Access Compliance Report

Public Rights-of-Way

(Curb Ramps)

Intersection ID: 26566	Main Street: ARBORHILL_RD	Cross Street: STIRRUP_RIDGE_LN	Location: SE
ADA ID: 121F1E537FD1	Ramp Type: Perp	Initial Pass/Fail: Fail	Overall Compliance: No
Severity Score: 12.5			
Codes/Mitigation Info/Possible Solution		Field Measurements/Component Compliance

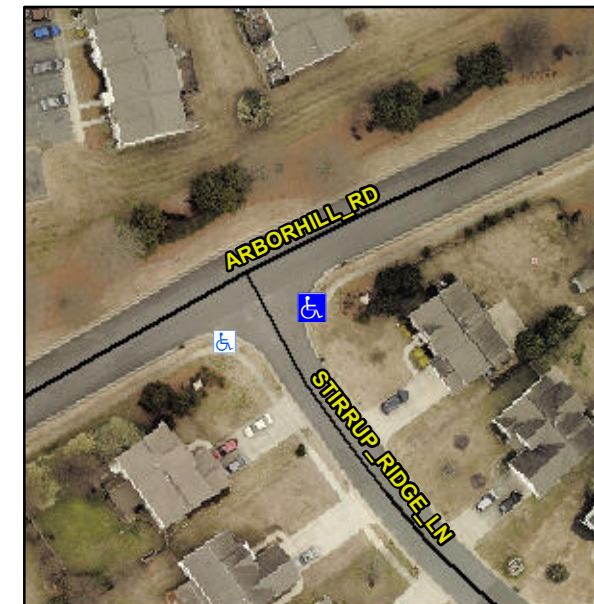
Not Found, R304.2.2

Compliance	Description	Data	Compliance	Description	Data
N/A	Ramp Length (in)	51.0	No	Ramp Slope (%)	11.6
Yes	Ramp Width (in)	51.0	Yes	Ramp XSlope (%)	0.2
N/A	Flare Type LT	N/A	N/A	Flare Type RT	N/A
N/A	Flare Slope LT (%)	N/A	N/A	Flare Slope RT (%)	N/A
N/A	Flare Traversable LT?	N/A	N/A	Flare Traversable RT?	N/A
N/A	Landing Length (in)	N/A	N/A	DWS Provided?	N/A
N/A	Landing Width (in)	N/A	N/A	DWS Contrast?	N/A
N/A	Landing Slope (%)	N/A	N/A	DWS Length (in)	N/A
N/A	Landing X Slope (%)	N/A	N/A	DWS Full Width?	N/A
N/A	Landing Curb? (Y/N)	N/A	N/A	DWS Offset (in)	N/A
N/A	Shared Landing?	N/A			
N/A	Gutter Ponding?	N/A	N/A	Gutter Slope (%)	N/A
N/A	Gutter Lip Ht (in)	N/A	N/A	Gutter X Slope (%)	N/A
N/A	Painted X Walk1?	No	N/A	Painted X Walk2?	N/A
	X Walk 1 Direction	To W		X Walk 2 Direction	N/A
N/A	X Walk 1 Width (in)	N/A	N/A	X Walk 2 Width (in)	N/A
	X Walk 1 Slope (%)	2.5		X Walk 2 Slope (%)	N/A
	X Walk 1 X Slope (%)	0.9		X Walk 2 X Slope (%)	N/A

Remove & Replace Entire Ramp.
